**North America's
Full Service
Jabiru Center**

SERVICE BULLETIN	
Service Bulletin #	JSA-003-1
Superseded Bulletin #	JSA-003
Issue Date	08/27/2009
Effective Date	08/27/2009
Limitations for Completion	Before the Next Flight
Make & Model Affected	J250-SP Serial # All
	J230-SP Serial # All
	J170-SP Serial # All
Page 1 of 5

Figure 1 – Undercarriage

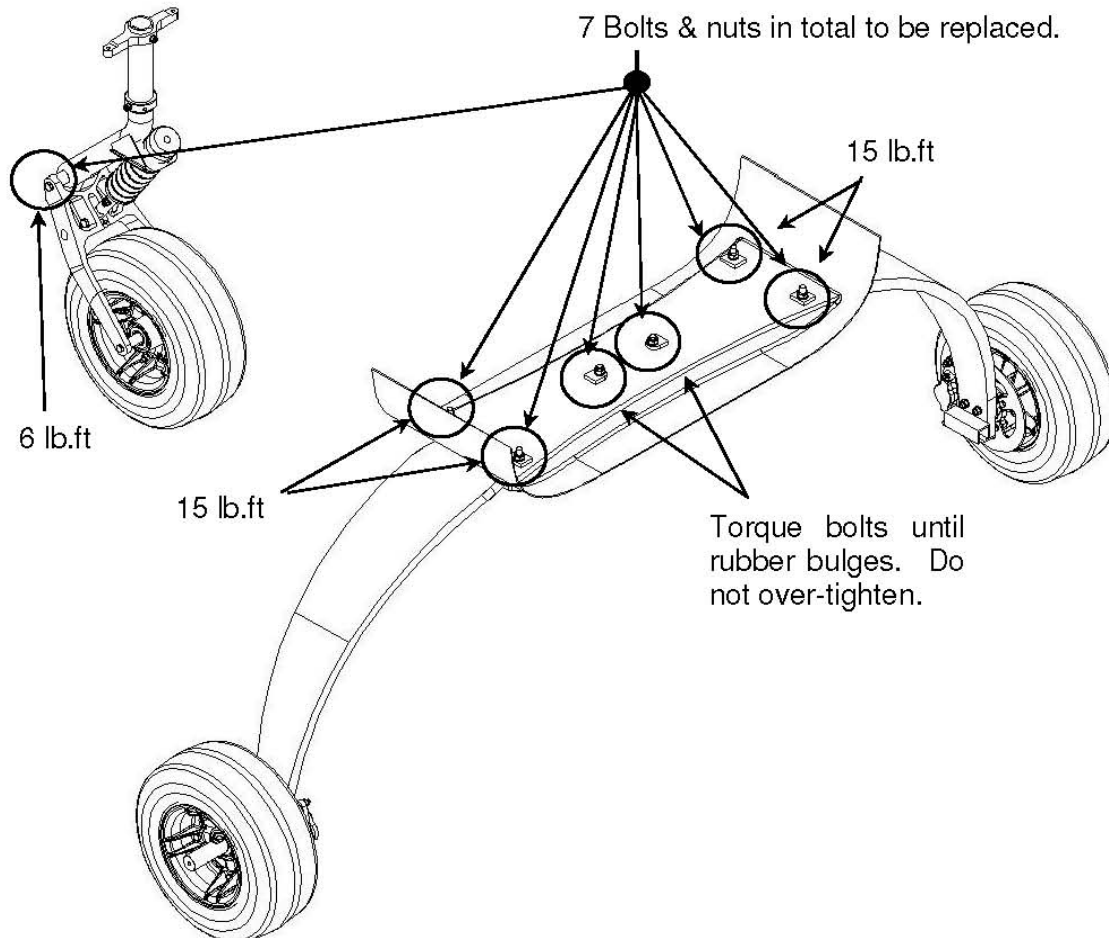
- Several bolts used in the undercarriage of Jabiru Aircraft are subject to relatively high loads and vibrations.
- To reduce the frequency of undercarriage bolt failures a 500-hour life has been applied to several critical bolts.

- Bolts and nuts used in the positions shown in Figure 1 are to be replaced at the first 100 hour inspection or annual condition inspection after 500 hours Time In Service (TIS).
- Bolts which have already surpassed 500 hours TIS are to be replaced at the aircraft's next 100-hourly or annual inspection.

- A procedure for removing the undercarriage legs is given in the Service Manuals of all Jabiru Aircraft and is to be used for this task.
- Figure 1 shows a general schematic of a tricycle undercarriage for a Jabiru Aircraft. The bolts which are to be replaced are indicated. While there are detail differences between Jabiru models all have the same general layout and have the same critical 7 bolts which are to be replaced.

- Note that because of differences in thickness of the fiberglass supporting structure the length of the bolts used in each position is not fixed. That is, the left-rear bolt of aircraft "A" is not necessarily the same length as the left-rear bolt of aircraft "B".

- The length of the new bolt fitted should match that of the old bolt being removed. Please confirm the correct length of the bolts for your aircraft before ordering bolt kits.

- Standard aircraft practices apply to nuts: when tightened no less than 1 and no more than 3 threads must show through the nut.

- The old bolts and the aircraft components are to be inspected while disassembled for indications of looseness, fretting or other damage and repaired / replaced as necessary.
